**CITY OF CONDON
WORK SESSION AGENDA
PLANNING COMMISSION 11-17-2020
Tuesday, November 17, 2020, 5:30 PM
CONDON CITY HALL**

Reference: Condon Grade School Site Plan Review Staff Report

City of Condon, Oregon
Grade School Site Plan Review Submittal
City Engineer Report
November 12, 2020

1 SITE PLAN - POWER

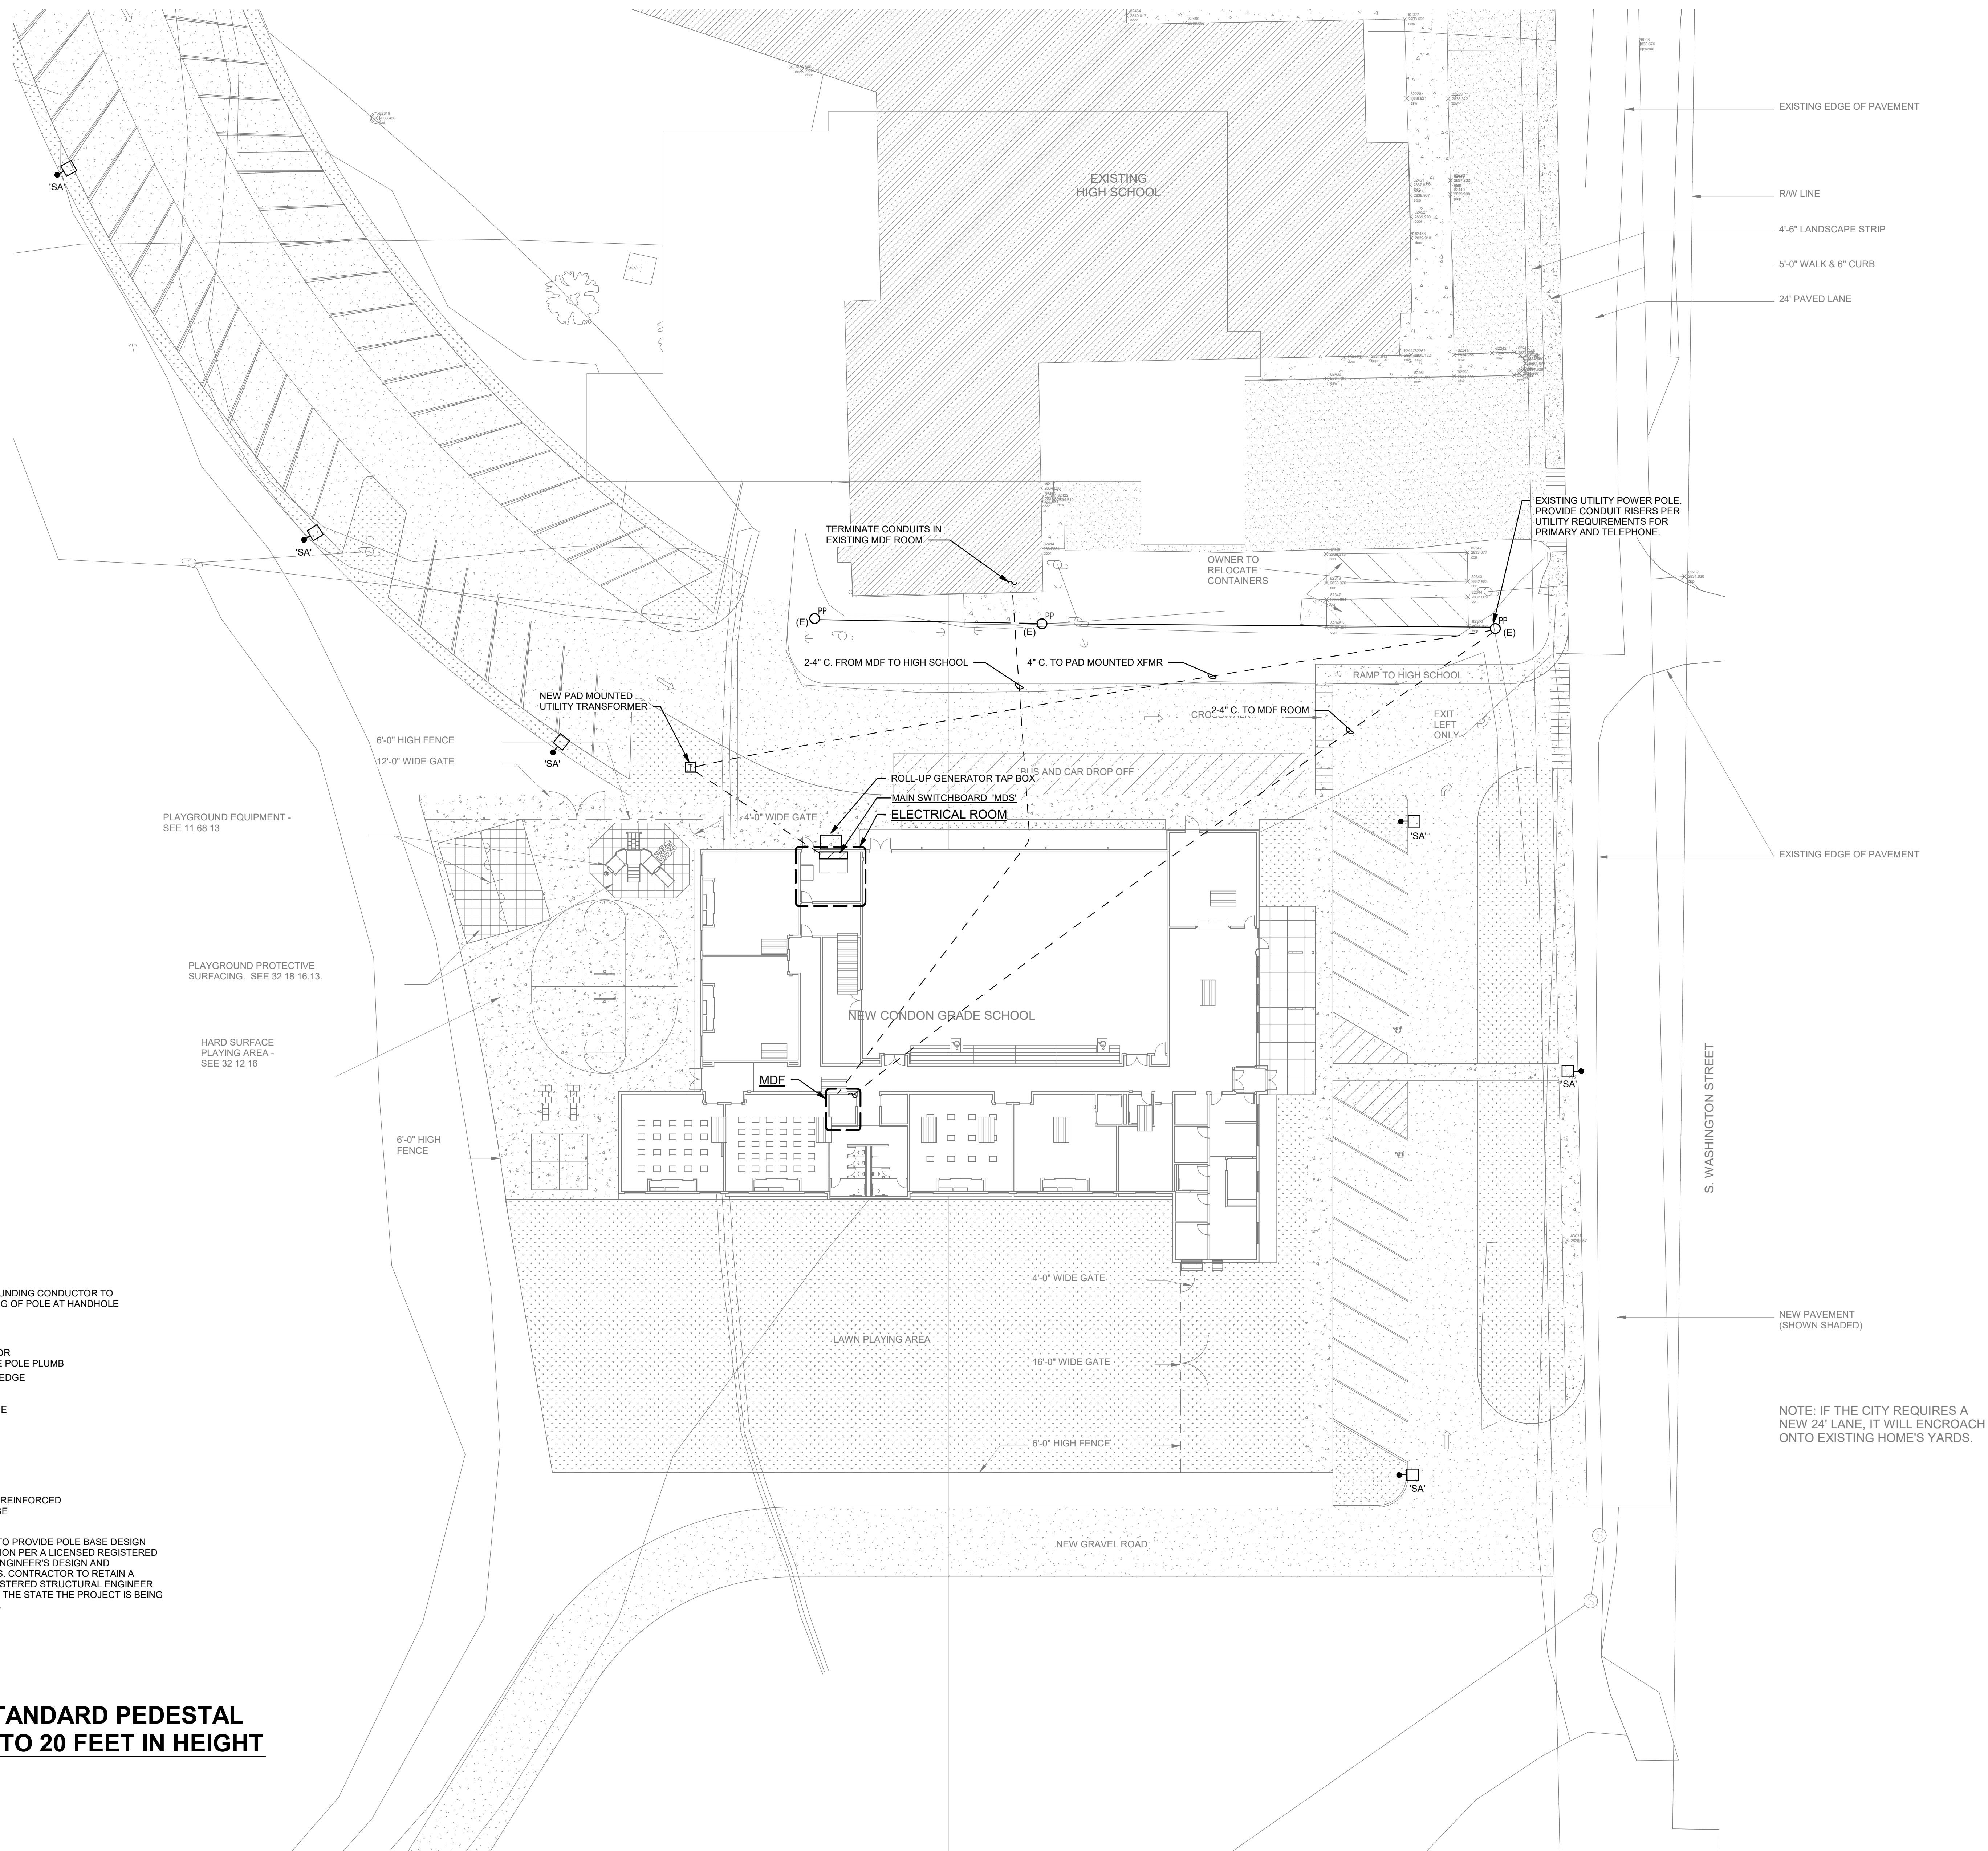
- A020 The paved road width noted on Sheet A020 does not appear to match the Civil Drawings.
- E102 Move proposed luminaire in City ROW to private property and out of the sidewalk.
